### **Re: 60 Valley Road and 150 Quarry Road, Langwarrin**

- (1) review the Amended Drawings and changes
- (2) provide a report detailing the neighbouring trees and discussing the likely impact if any to them, as a result of implementing the plans.

The design drawings upon which I base my assumptions are the Amended Drawings by Dartmouth Consulting, including figures WP01Rev B – WP03 Rev B dated 25/Oct/24, WP04 Rev B dated 27/03/25 and the Rev B sections dated 27/03/25.

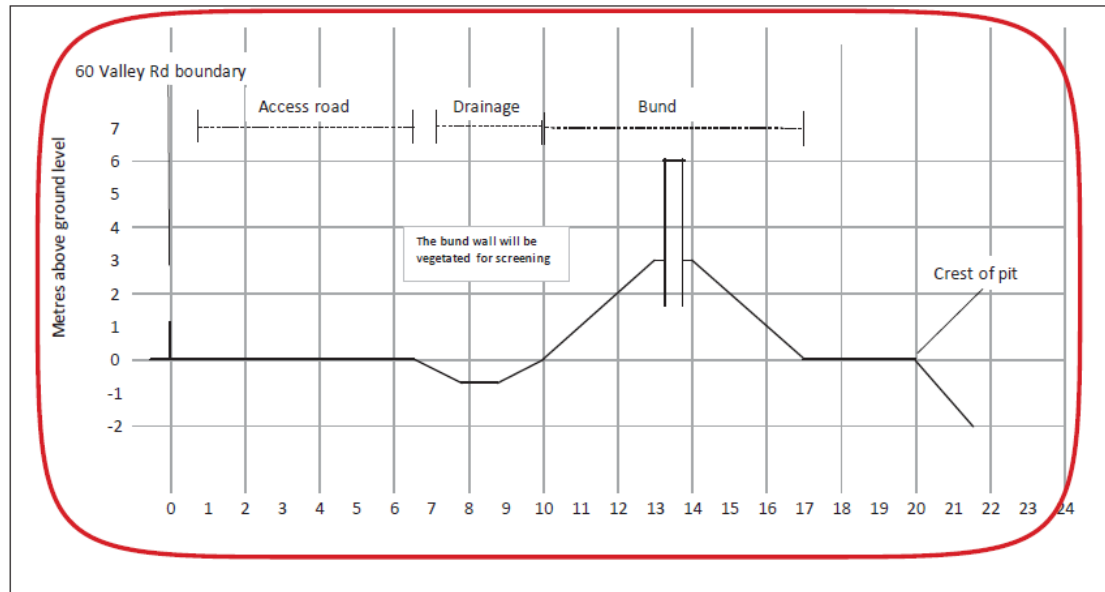
The below represents a section from page 13 of the Amended Plans. It is apparent that along the northern boundary, i.e. opposite trees 1-46, there is not proposed to be any excavation within an approximately 6.3m wide strip. The land use of an infrequently used track adjacent to the inside of the boundary is proposed to remain the same, with no alterations. None of the TPZs of any of the neighbouring trees to the north protrude anywhere near 6.3m into the subject site, let alone 10% of the TPZs. Thus one can be extremely confident that there will be no impact on any of these trees from the proposal.

The Amended Plans according to drawings WP01 Rev B dated 27/Mar/25 and the section above can be readily implemented in a manner in which one may be extremely confident that there will be no adverse impact on any of the neighbouring trees.
